May 11, 2015

SUBJECT: Contract 008066
SR 520, Floating Bridge and Landings Project
Federal Aid No. BR-0520(047)
Change Order No. 191 – November 13, 2014 Project Resolution

Attached for Headquarters Construction execution and further processing is Project Office recommended Change Order No. 191 – November 13, 2014 Project Resolution.

#5 threaded-type rebar coupler, epoxy coated

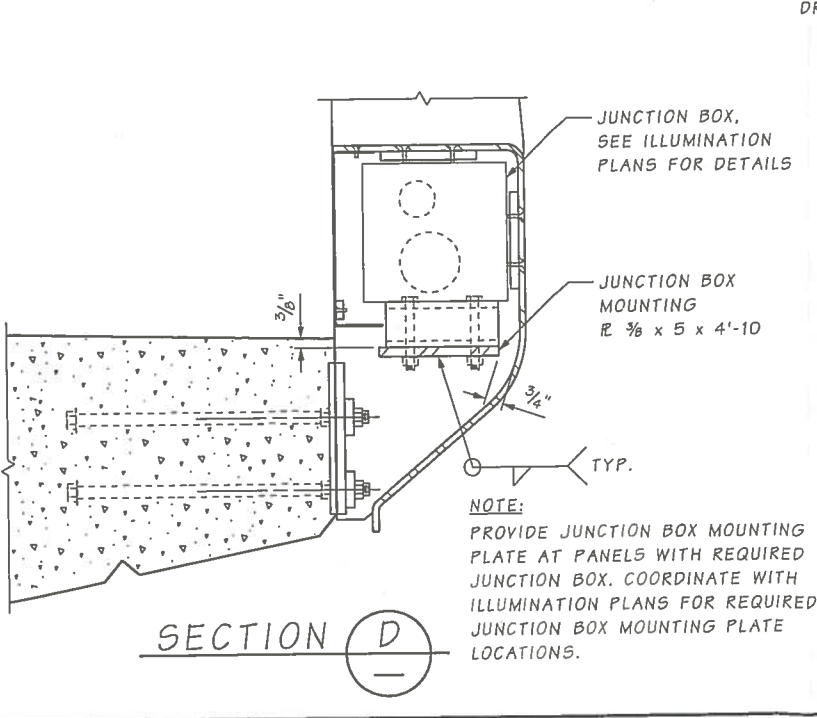
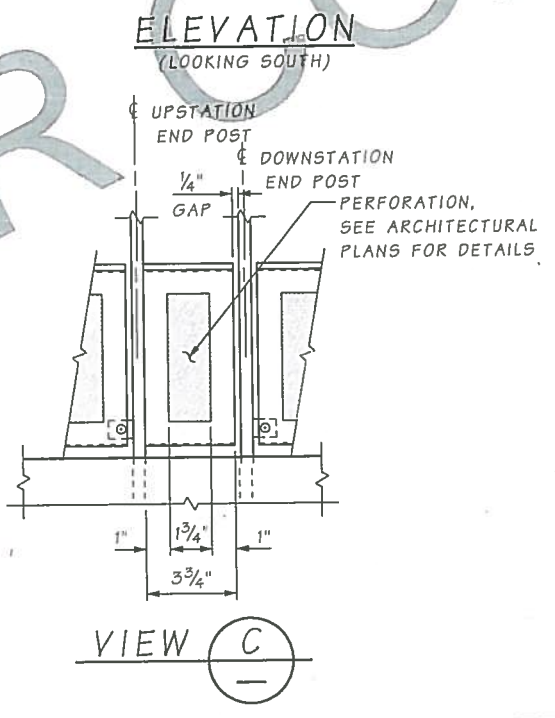
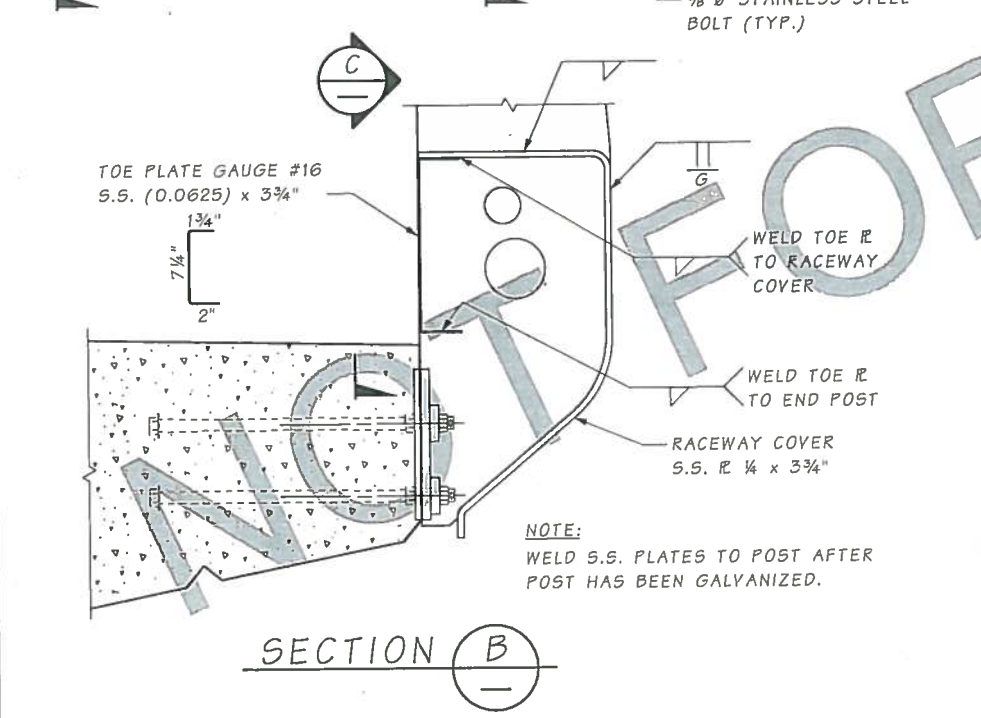
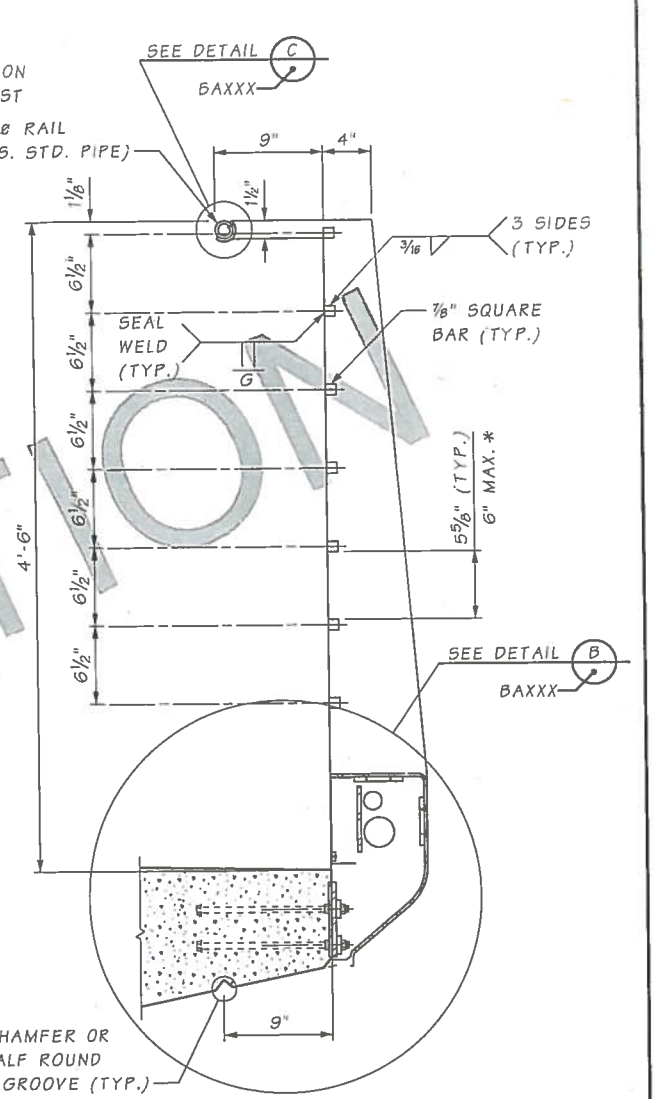
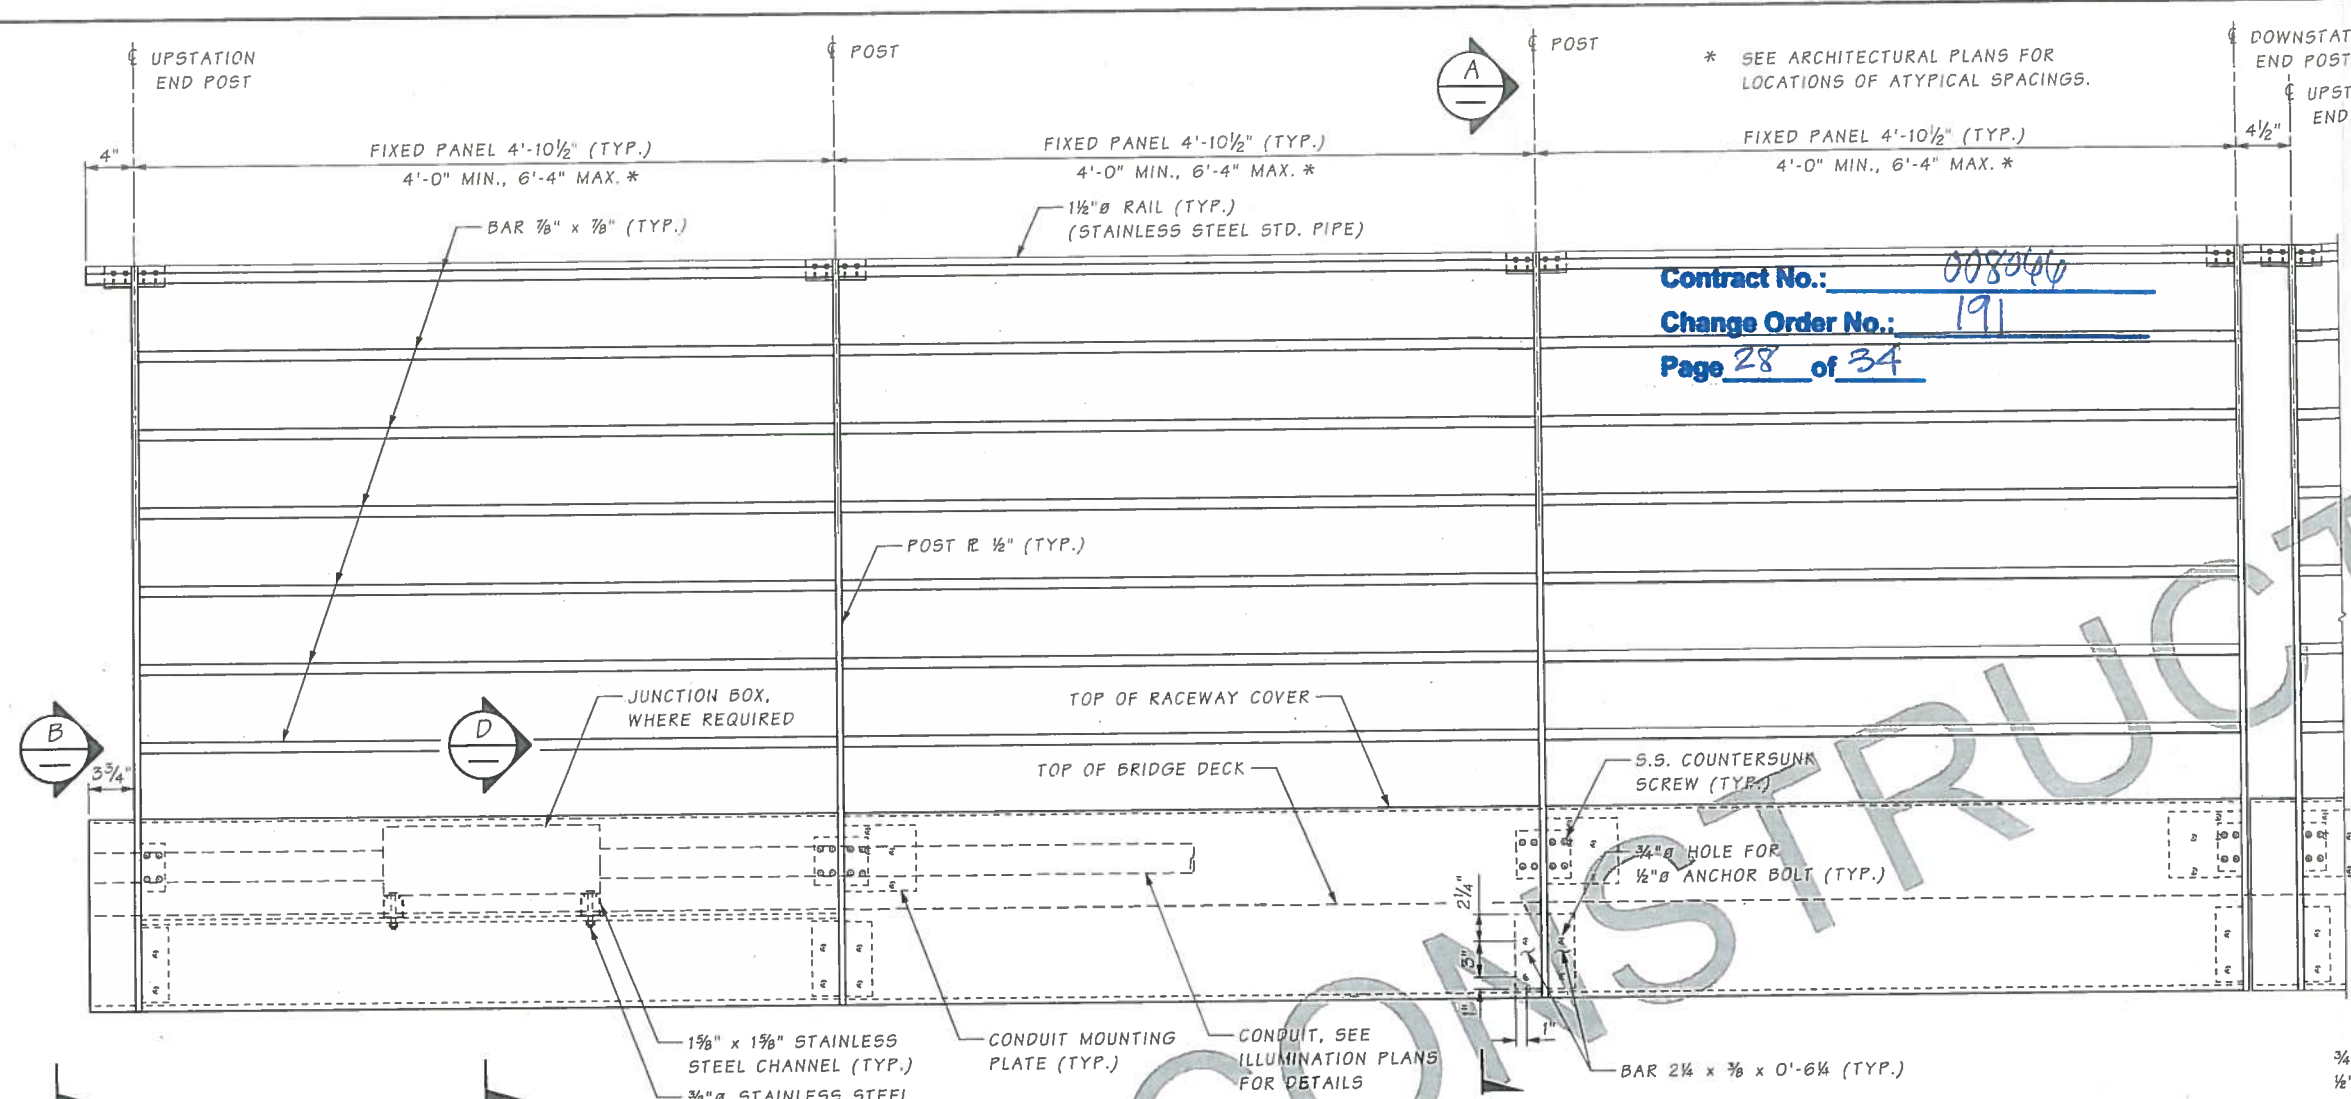
4.78 = Approx length of portion of western-most interior segment on FB&L-constructed deck (ft)
5 #4 couplers with in-deck portion of Mark 2S342 bars in FB&L plan sheet T2.38
12 #5 couplers with in-deck portion of Mark 2S142 bars in FB&L plan sheet T2.38

6 = Typical interior segment length (ft)
19 # of typ interior segments
For one interior segment:
7 #4 couplers with in-deck portion of Mark 2S342 bars in FB&L plan sheet T2.38
16 #5 couplers with in-deck portion of Mark 2S142 bars in FB&L plan sheet T2.38

2 = East end segment length (WABN constructed between scupper and barrier CJ) (ft)
2 #4 couplers with in-deck portion of Mark 2S342 bars in FB&L plan sheet T2.38
6 #5 couplers with in-deck portion of Mark 2S142 bars in FB&L plan sheet T2.38

140 #4 couplers with in-deck portion of Mark 2S342 bars in FB&L plan sheet T2.38
322 #5 couplers with in-deck portion of Mark 2S142 bars in FB&L plan sheet T2.38

Couplers shall meet the requirements of Std. Spec. 6-02.3(24)F

Each coupler shall have a internal coupler protector (plastic cap) on the top end

TYPICAL SECTION - SPAN 35

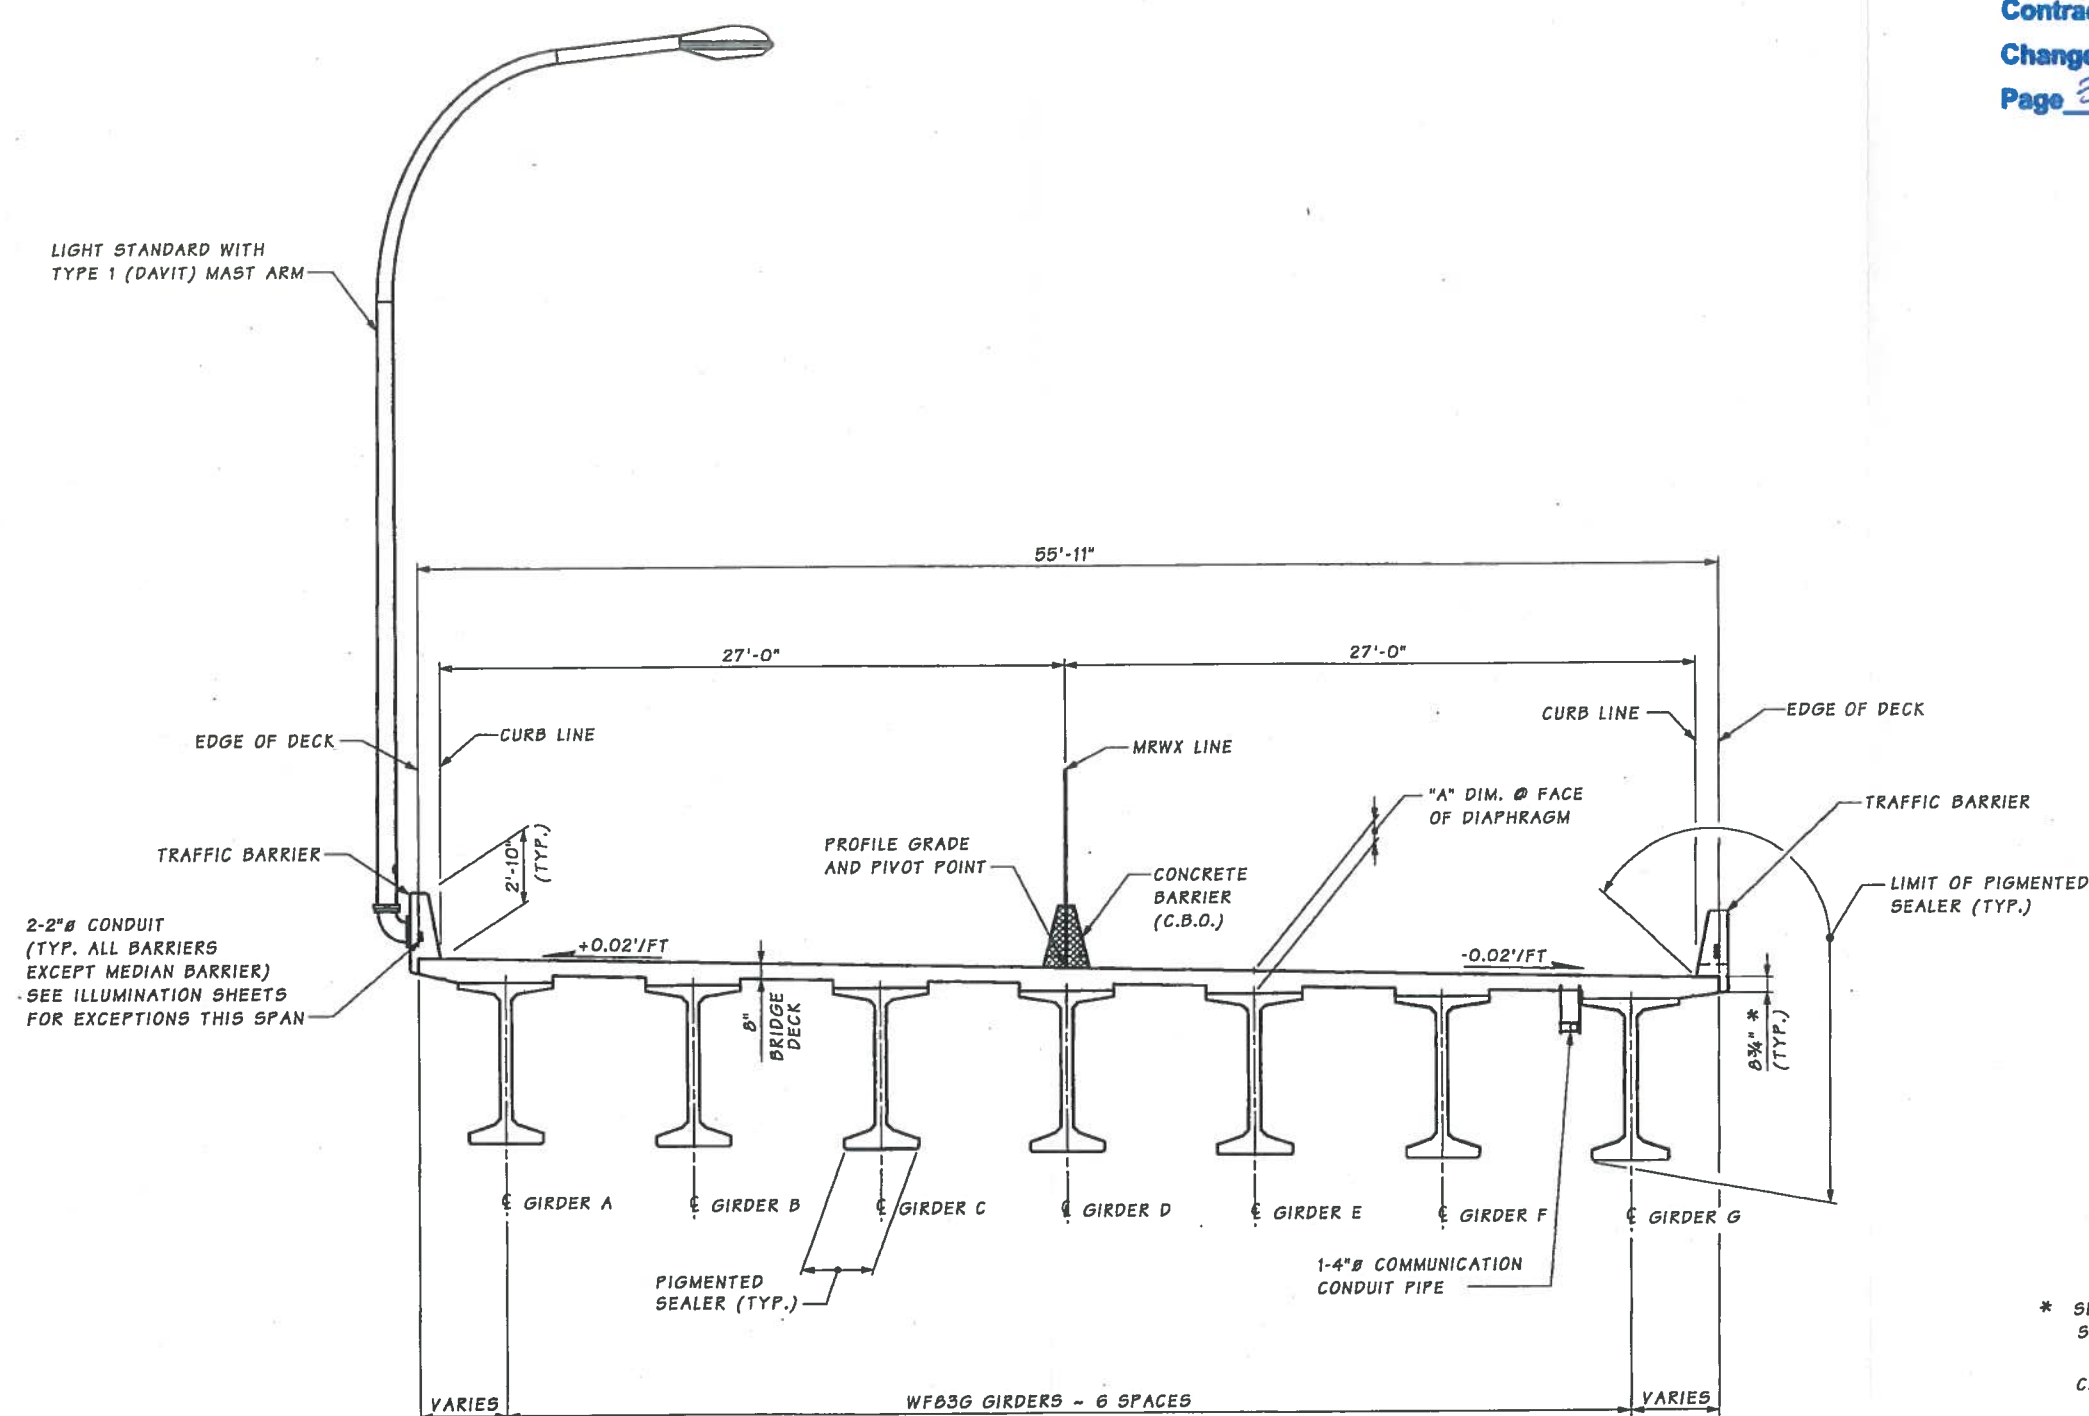
“The Design-Builder shall grind the existing surface of Span 35 of the West Connection Bridge, as identified on pages 33 and 34 of 008066 Change Order No. 191. Grinding shall be in accordance with Section 2.7.5.3 Next Generation Concrete Surface.”

**KGM PROPOSED DESIGN
DETAIL A**

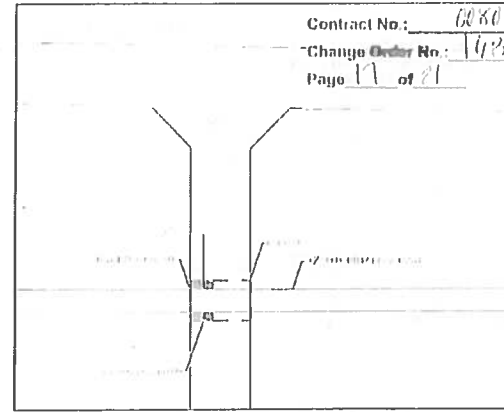
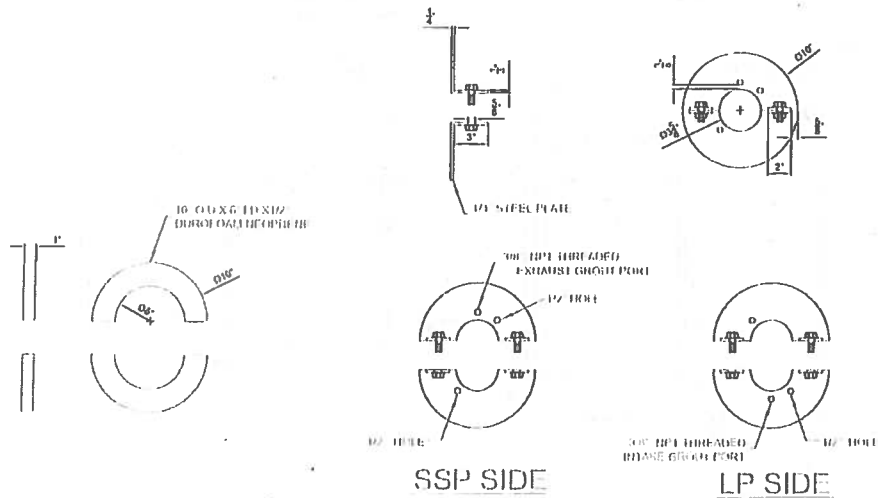
Appendix M23 Outfitting and Assembly Minimum Technical Requirements, Bridge Sheet No. A9 "Pontoon Assembly Details 7", shall be revised as follows:
